IEC 60950-1

Edition 2.0 2013-05

AMENDMENT 2
AMENDEMENT 2

**Information technology equipment – Safety –
Part 1: General requirements**

Figure 2E.1 – Voltages in SELV circuits under single fault conditions for a single pulse above V_1

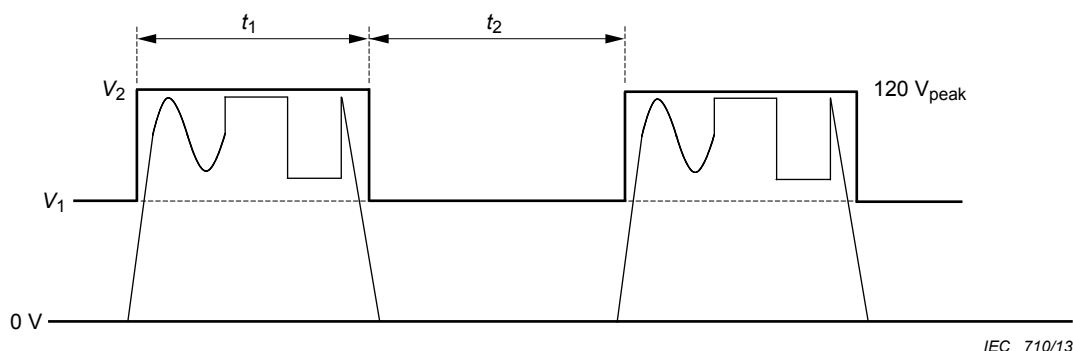
Replace, in the existing first paragraph of this subclause, the existing words "Figure 2E" by "Figure 2E.1 and Figure 2E.2" (two instances).

Replace in the existing first paragraph of this subclause the value "120 V d.c" by "120 V_{peak}".

A limit of 120 V_{peak} applies if the pulse goes above V_1 only once during time t_1 , for example see Figure 2E.1.

Replace the existing Figure 2E by the following new Figures 2E.1 and 2E.2:

Figure 2E.2 – Voltages in SELV circuits under single fault conditions for multiple pulses above V₁

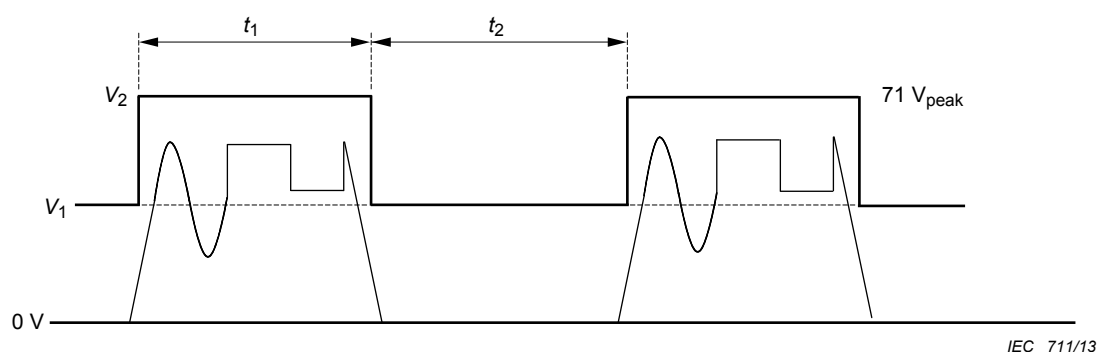
A limit of 71 V_{peak} applies if the pulse goes above V_1 more than once during time t_1 , for example see Figure 2E.2.

Figure 2H – Examples of application of insulation

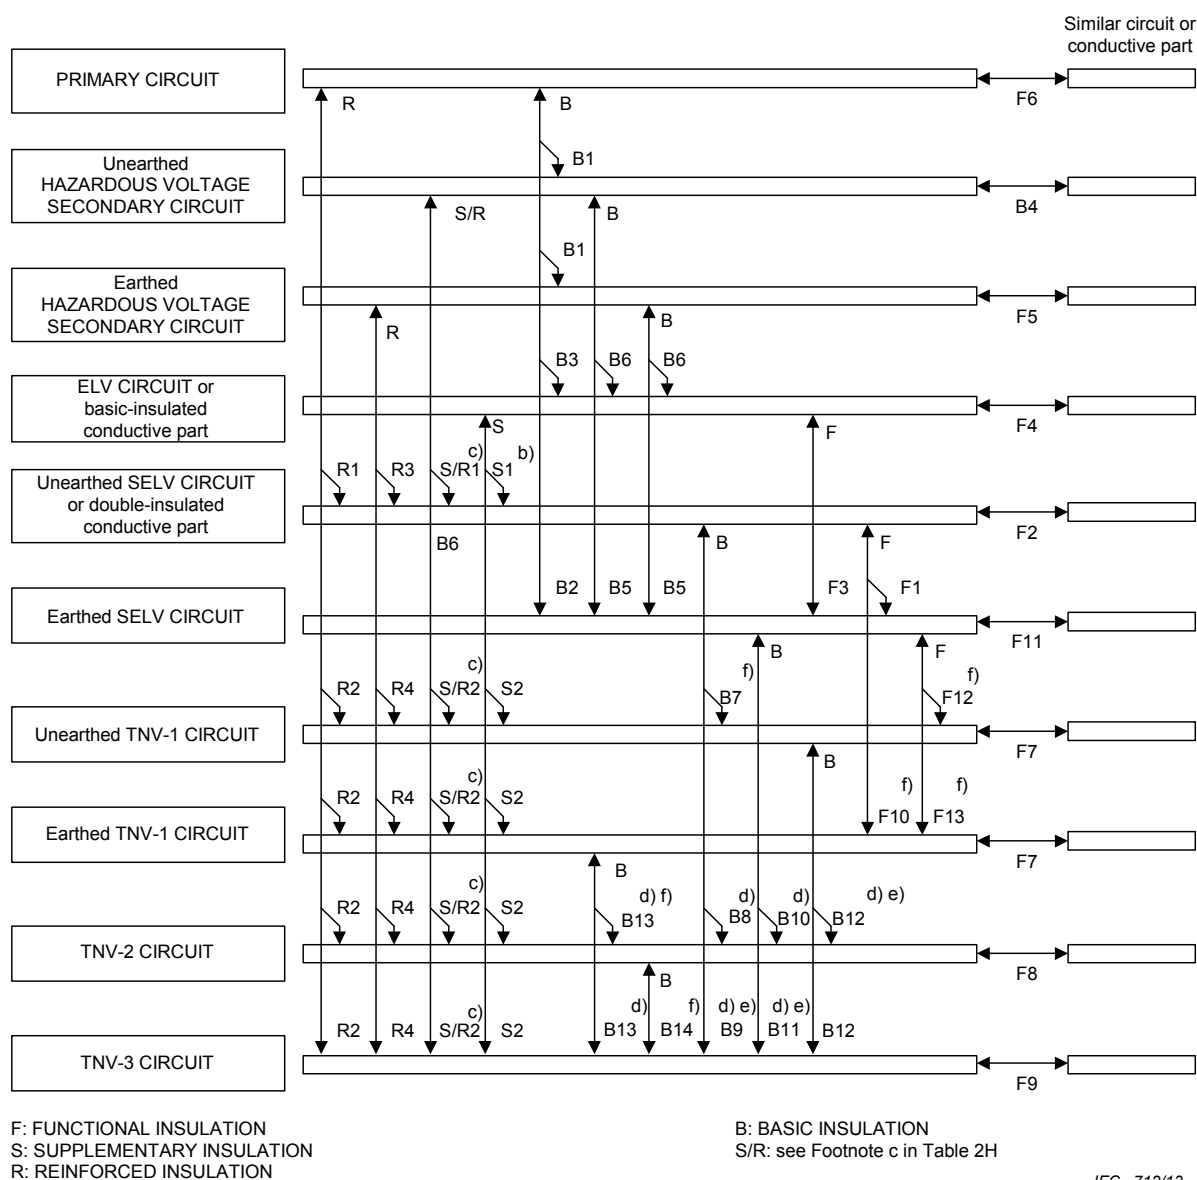
Replace the existing figure, including the note, by the following new note and figure:

NOTE The references b), c), d), e) and f) refer to the corresponding footnotes in Table 2H.

Figure F.8 – Narrow recess

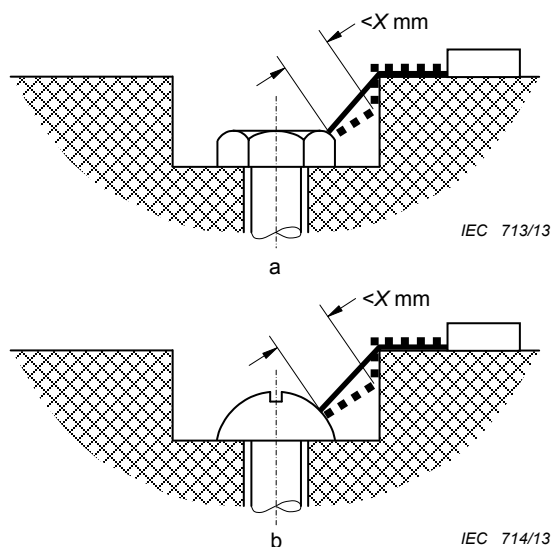
Replace the existing figure by the following new figure:

Gap between head of screw and wall of recess too narrow to be taken into account.

Measurement of creepage distance is from screw to wall where the distance is equal to X mm.
